Reserve 980, Former Schofields Aerodrome, Access off Aerodrome Drive, Nirimba Fields NSW 2763

Audit Number: MP169_07

Site Audit Report

Defence Housing Australia

Figure 1: Site Layout and Previous Historical Samples

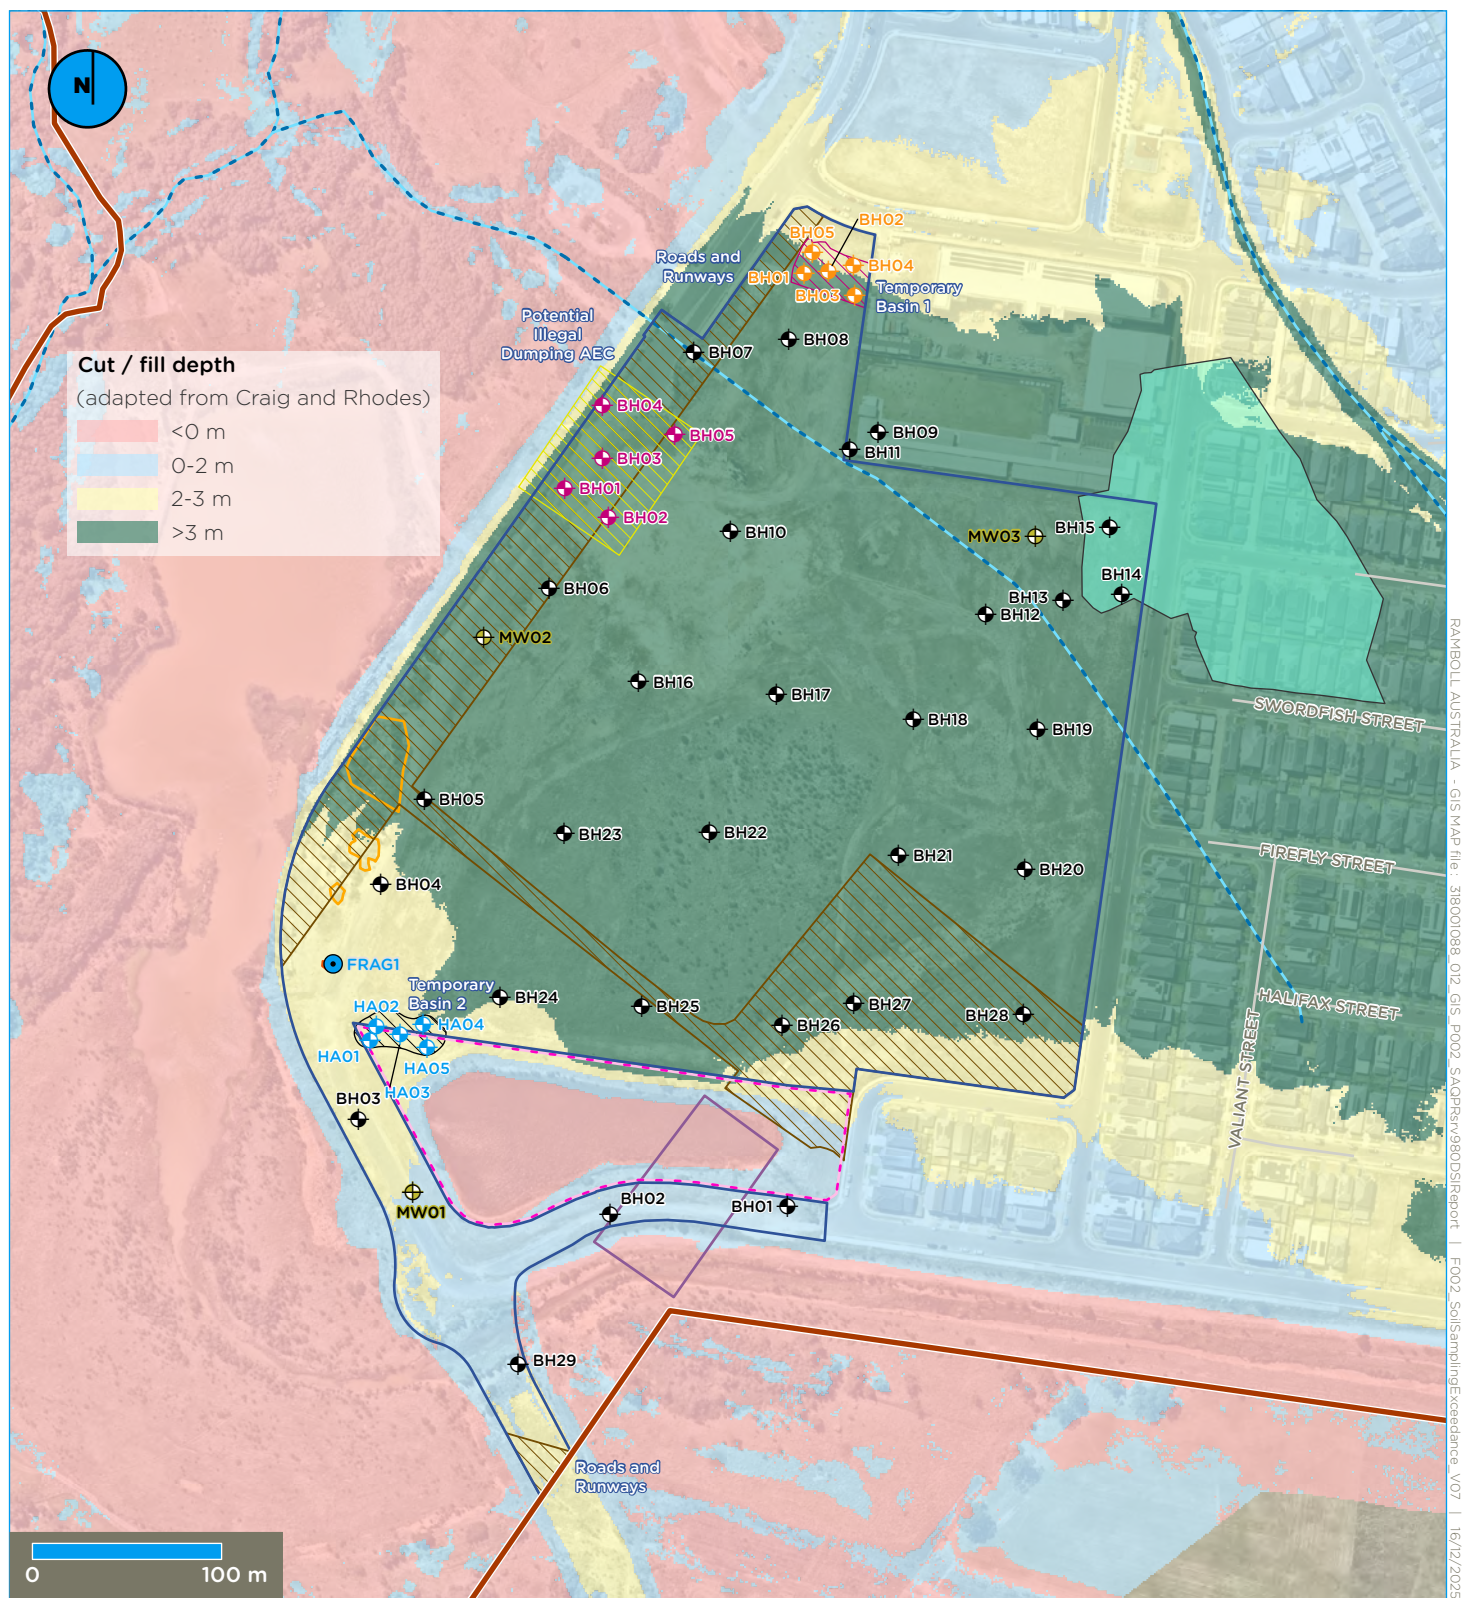
21. Section 6.1: given that MW05 is located adjacent to the western boundary of Reserve 980 (down-gradient), it is recommended that MW05 be sampled and gauged as well. Please add MW05 to Figure 1 and amend throughout the SAQP.

20. Section 9: Figure 1 (Appendix 1) shows that a new groundwater monitoring bore (located off-site within Hatched Area) is proposed at Valiant Street east of Reserve 980. If this off-site bore is installed in time (depending on timing of field program), the results of this off-site bore located up-hydraulic gradient should be considered when preparing the Reserve 980 DSI report.

1. Section 1.1: Given that the 'site' as shown in Figure 1 (Appendix 1) covers land external to the area specifically referred to in DA 21-00925, are there other DA relevant to the site? It would help to have a figure showing the area covered by DA 21-00925 and other DAs. This would assist DHA and the auditor in checking that the requirements of the Council have been met.

Figure 2: Soil Sampling Locations and Exceedances

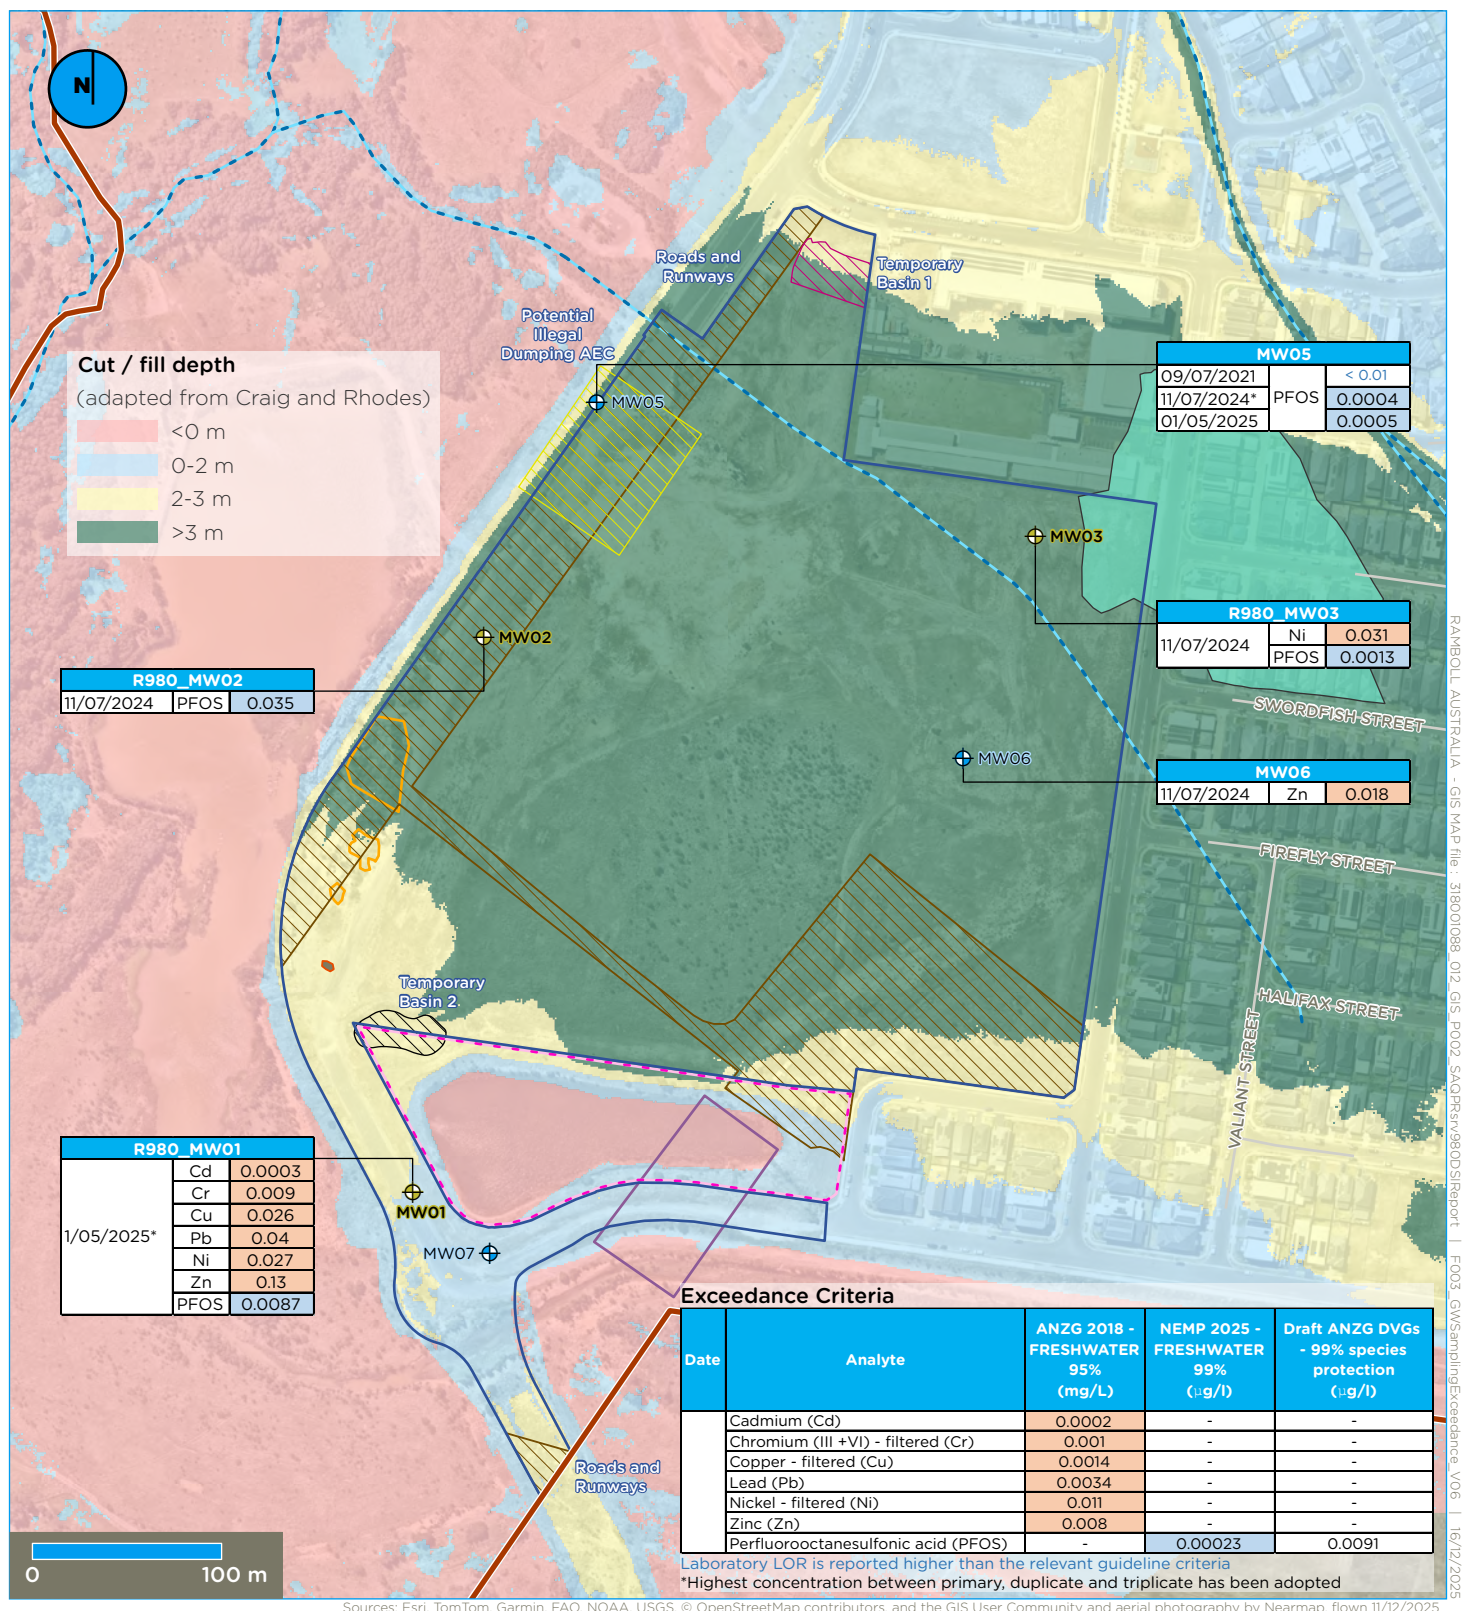
11. Section 5.6: Is the 'potential illegal waste dumping' area of environmental concern (AEC), shown in Figure 1 and 2 of Appendix 1, the same area discussed in Section 5.5?

7. Section 5.5: now that Ramboll has clarified the 'potential illegal waste dumping' area of environmental concern (AEC) shown in Figure 1 and 2 of Appendix 1 is not the same AEC discussed in Section 5.5, please show the location of the Section 5.5 illegal waste dumping area in the figures.

Figure 3: Groundwater Monitoring Well Locations and Exceedances

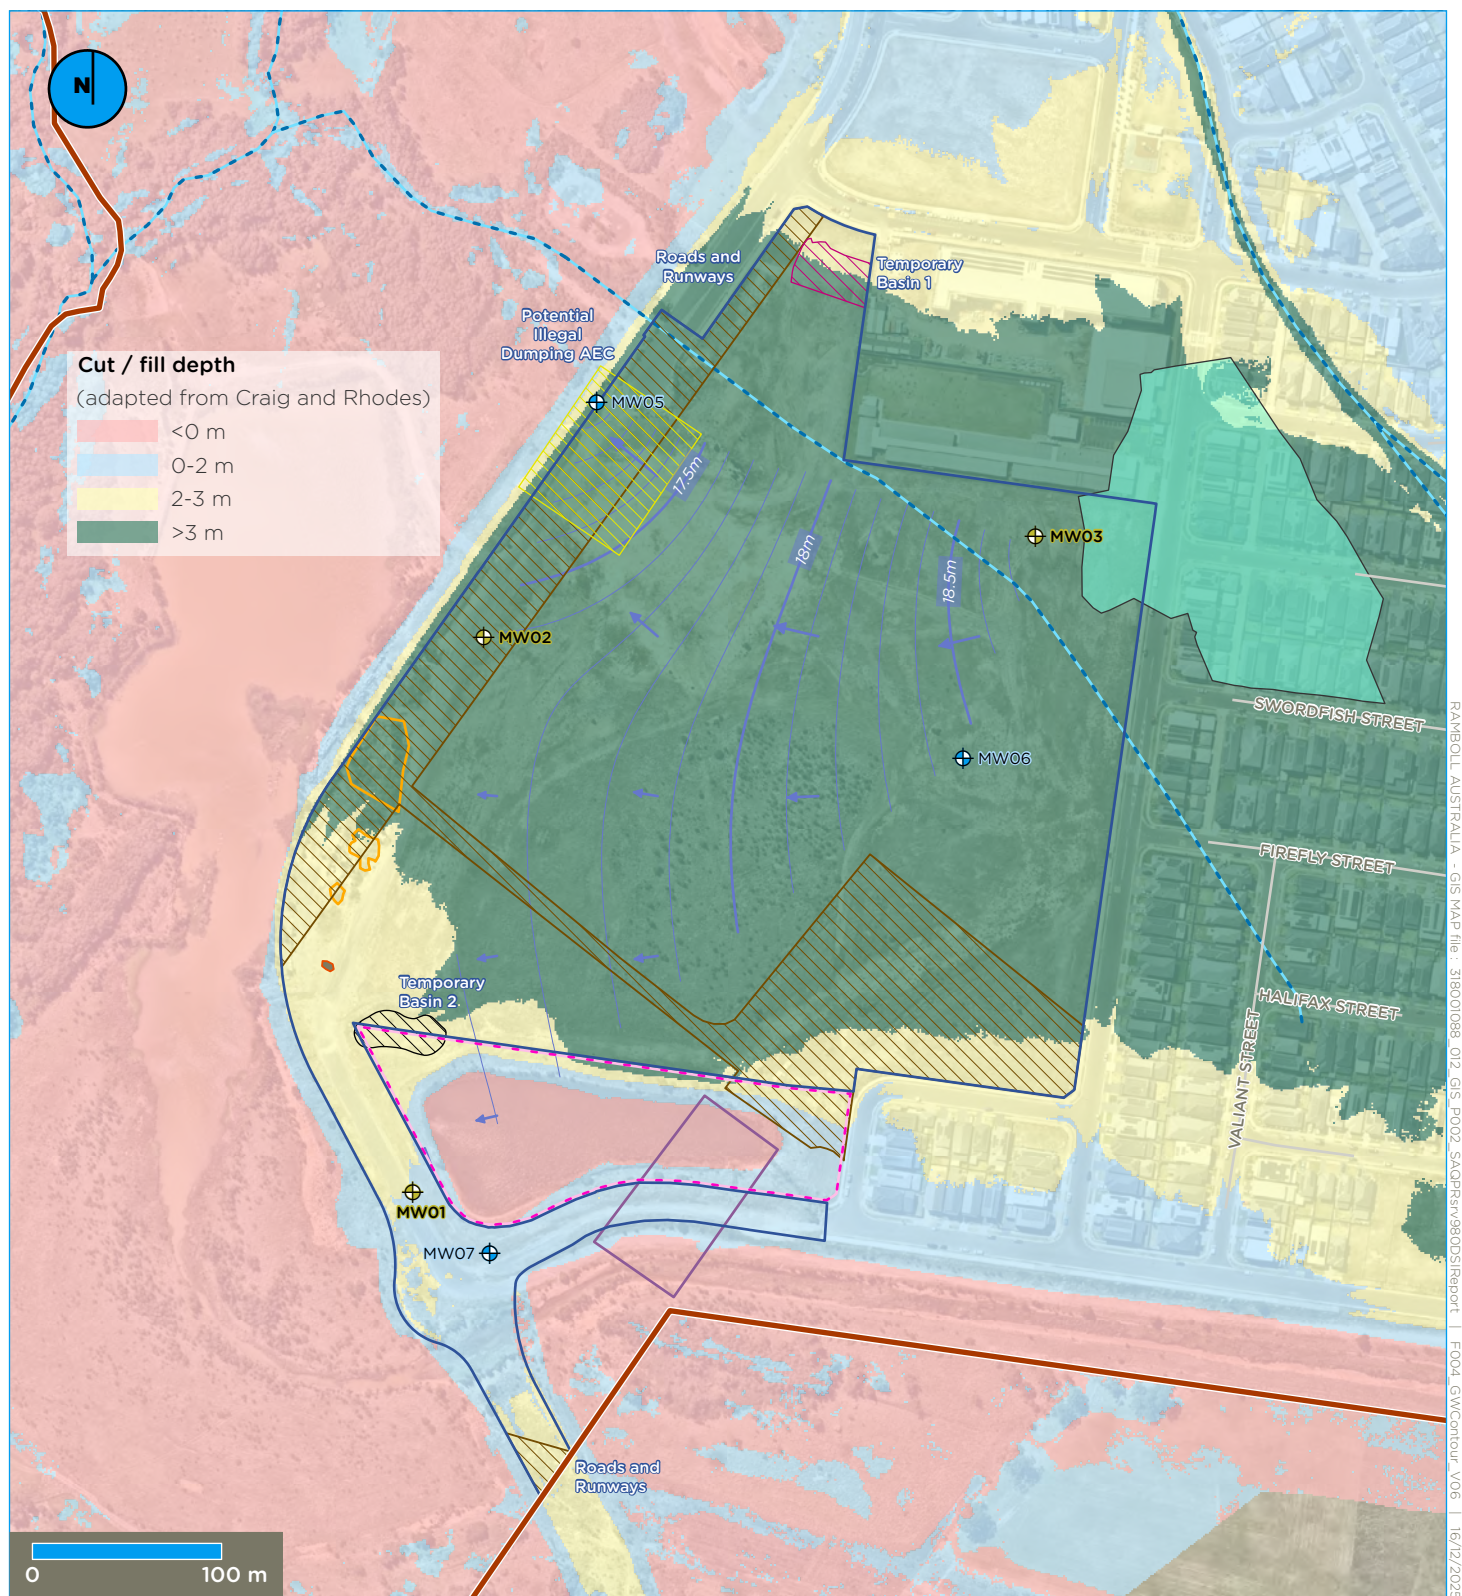
22. Section 6.1: MW07 is stated in Figure 1 to be destroyed. Is there any groundwater data available for the southern half of Reserve 980? The auditor notes that MW07 was last sampled on 8 July 2021 but it was only analysed for PFAS. This data gap needs to be addressed.
